Appendix D. Comments and Responses

Comments - Natural Resources Defense Council (NRDC)

Comments on proposal to weaken and not fully implement Fall X2 action in 2017

Figure 22. The Percentage of Time With Salinity < 6 for X2 = 74 km, As Used in the Hydrodynamics-Based Station Index Analysis.

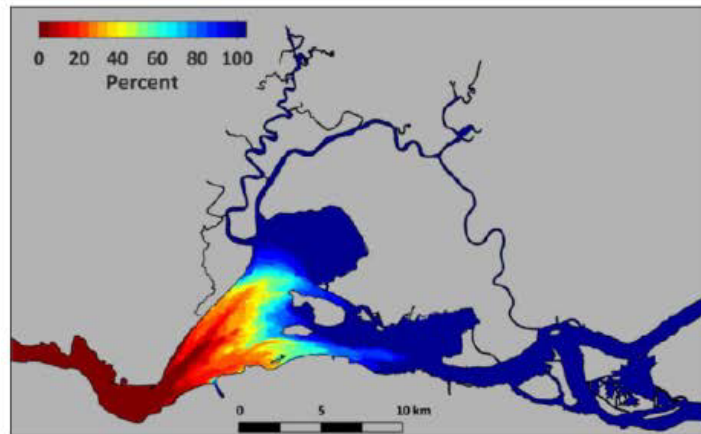
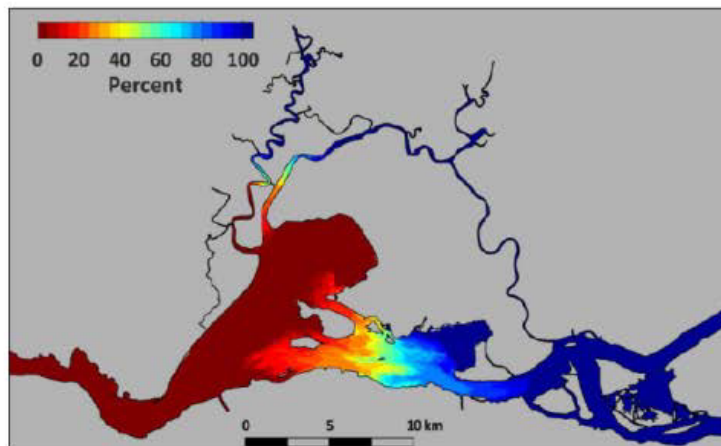
Fully implementing the Fall X2 action at 74 km allows the species to access important, highly productive habitat in Suisun March and Suisun Bay. For instance, Bever et al 2016 emphasized that, "Two key regions for Delta Smelt are Grizzly Bay and Honker Bay, where shallow and flat shoals promote wind-driven resuspension of sediment that increases turbidity." When X2 is at 74 km, the low salinity zone overlaps with both Honker Bay and Grizzly Bay, as the graphic below shows:

NRDC-10

In contrast, maintaining X2 at 81 km eliminates much of the low salinity habitat in Grizzly Bay and other parts of Suisun March and Bay, preventing Delta Smelt from effectively using this portion of designated critical habitat:

NRDC-10: The Proposed Action has been modified to 80 km to maintain favorable salinities in Grizzly Bay for Delta Smelt in October (page 21-22). Text has been updated.

Figure 1.

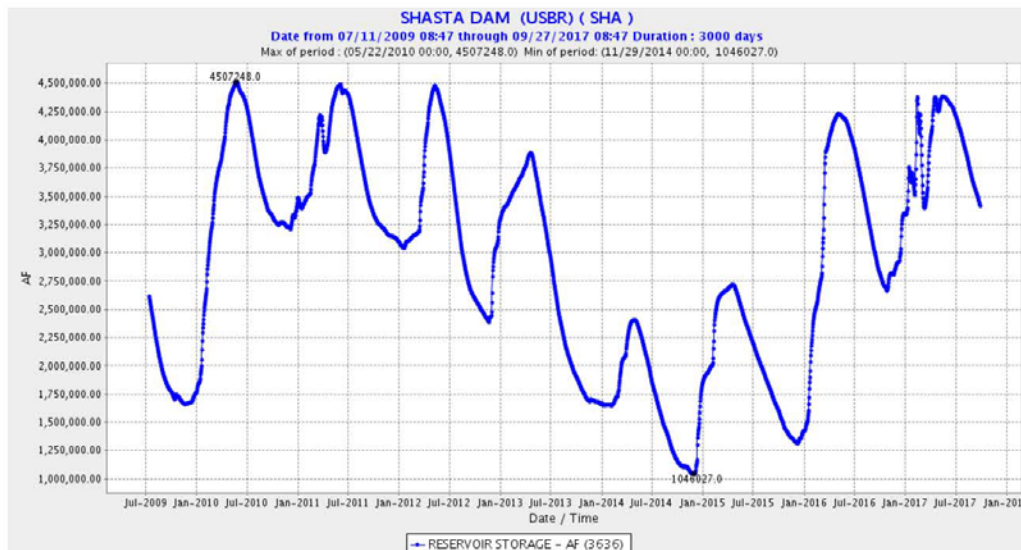
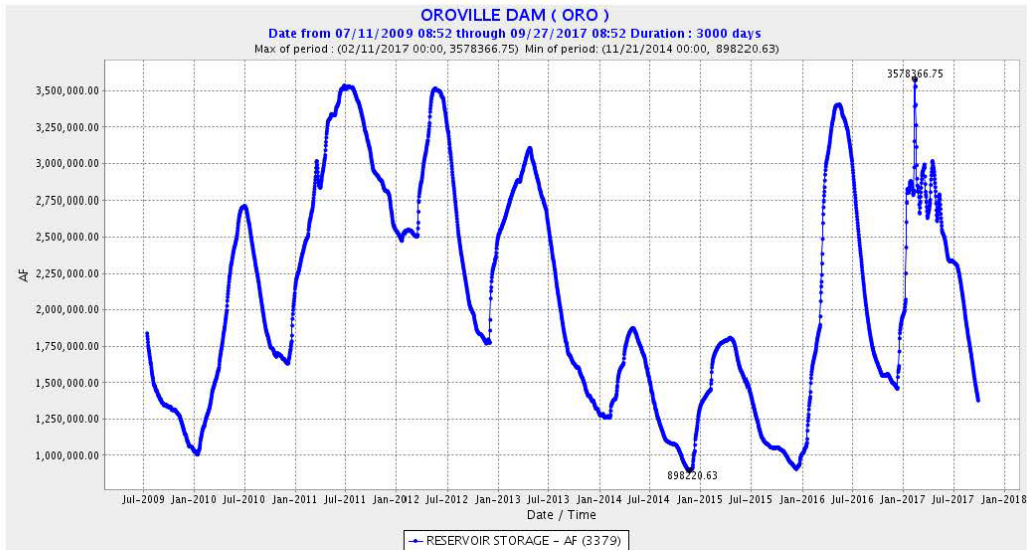
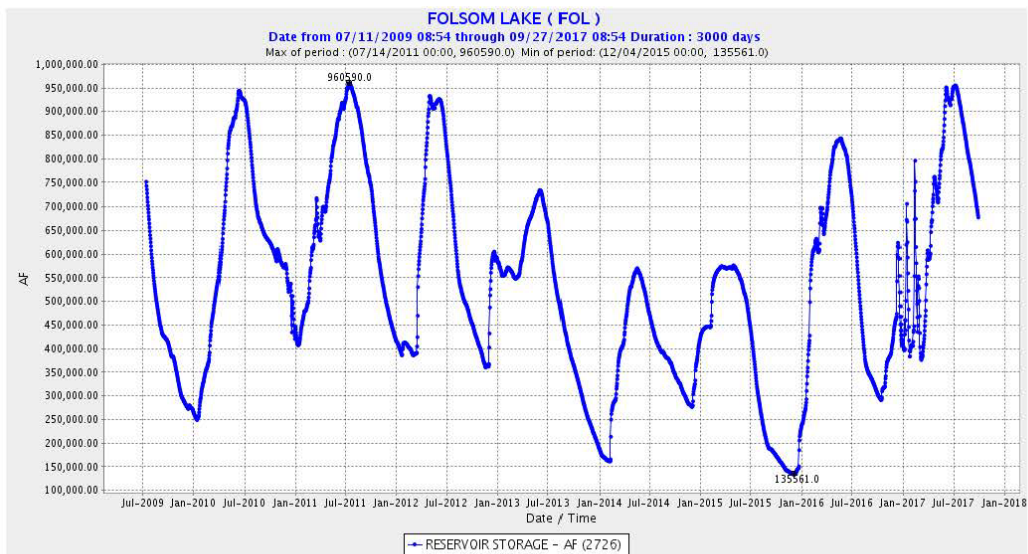
Comment: end of summer storage levels and water supply are not at drought levels (Figures 1-3). Shasta and Folsom remain at wet year levels. Oroville is at dry to below normal levels. Maintaining X2 near 74km will require a Delta outflow of approximately 10,000 cfs (Figures 4 and 5). That would require about 4000 cfs or about 250TAF during October from Folsom and Shasta above that requested in the letter. The three reservoirs have sufficient storage to maintain X2 near km74. Furthermore maintaining inflow is necessary to keep net flow positive at Jersey Point in the lower San Joaquin River channel of the west Delta (Figure 6). Negative flow conditions have been excessive through the summer.

CANNON-1: Text has been updated to reflect storage at Oroville (page 9). Upstream storage and releases would not change between the Proposed Action and the No Action Alternative.

Figure 4.

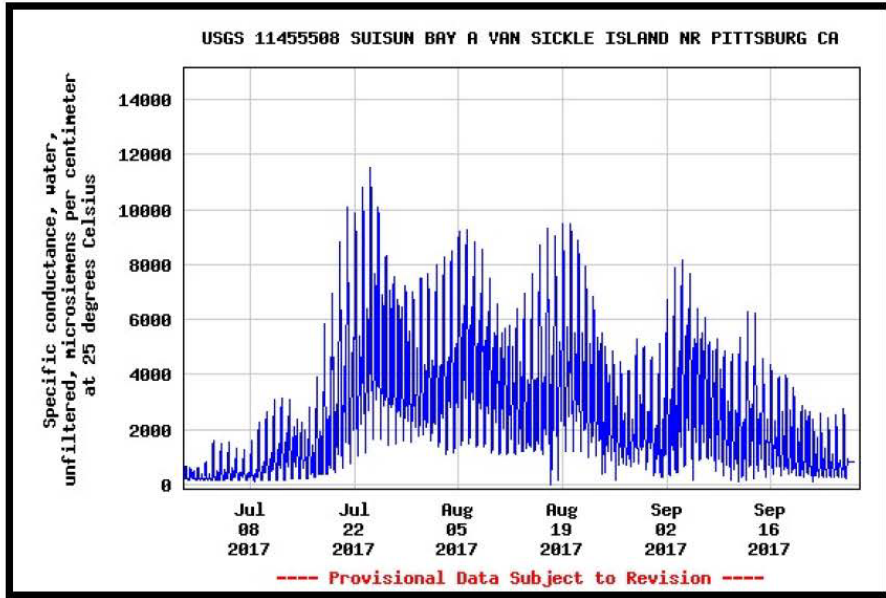
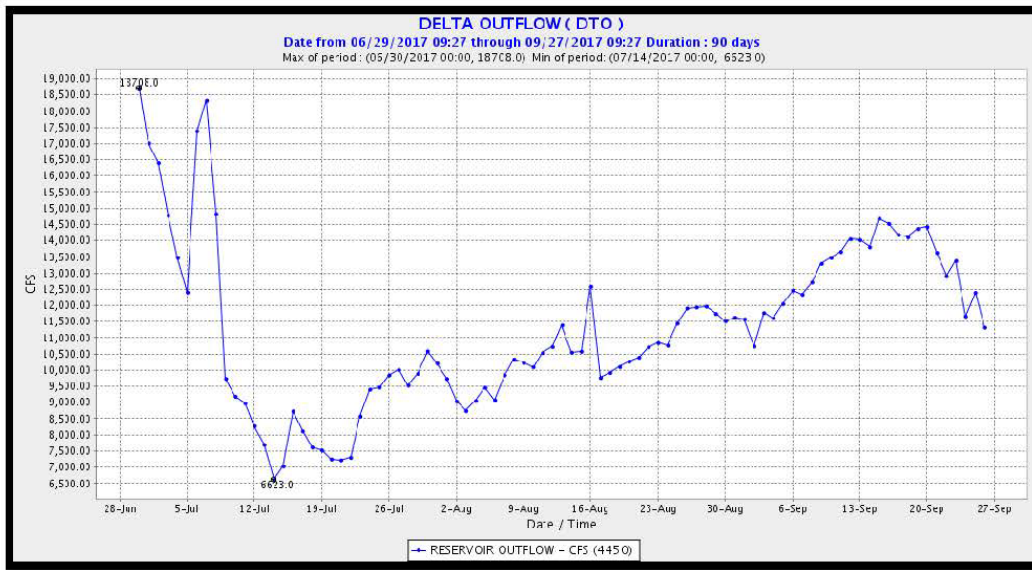
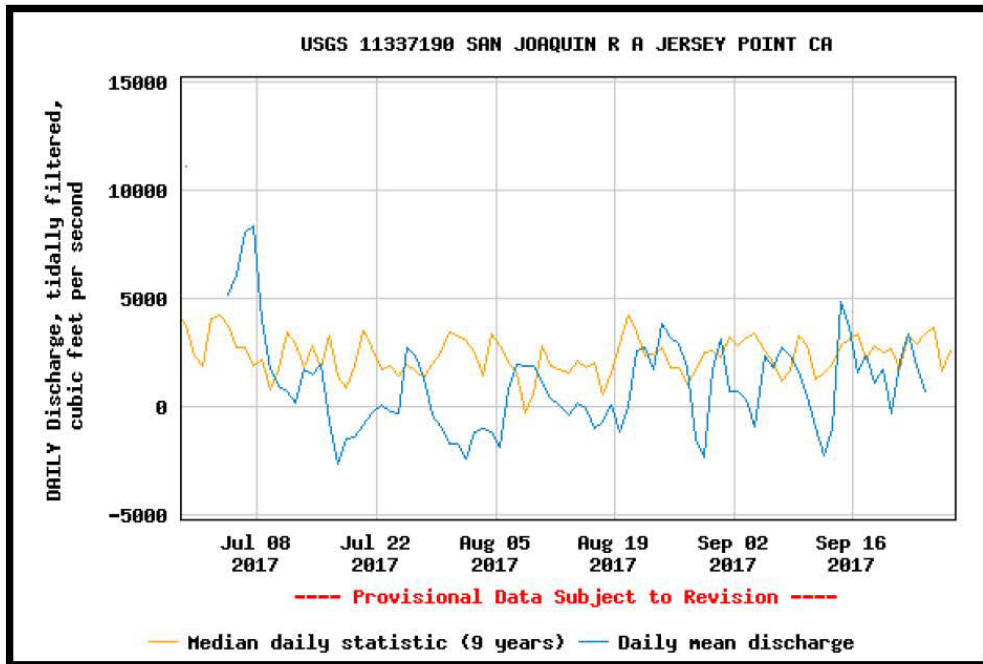
the proposed Fall X2 action for 2017 would not adversely affect Delta Smelt. P5. **Comment:** there is no basis for this conclusion. Reductions in Delta outflow, upstream movement of X2 into the western Delta, and negative net flows at Jersey Point are a direct and real threat to Delta smelt and their habitat. With the species on the brink of extinction, such “adaptive” negative management actions are not the logical approach to be taken in the present situation.

CANNON-2: The Proposed Action has been updated based on consultation with the Service. Text has been added and updated to reflect the Service's determination and the change to 80 km (page 6, 26).
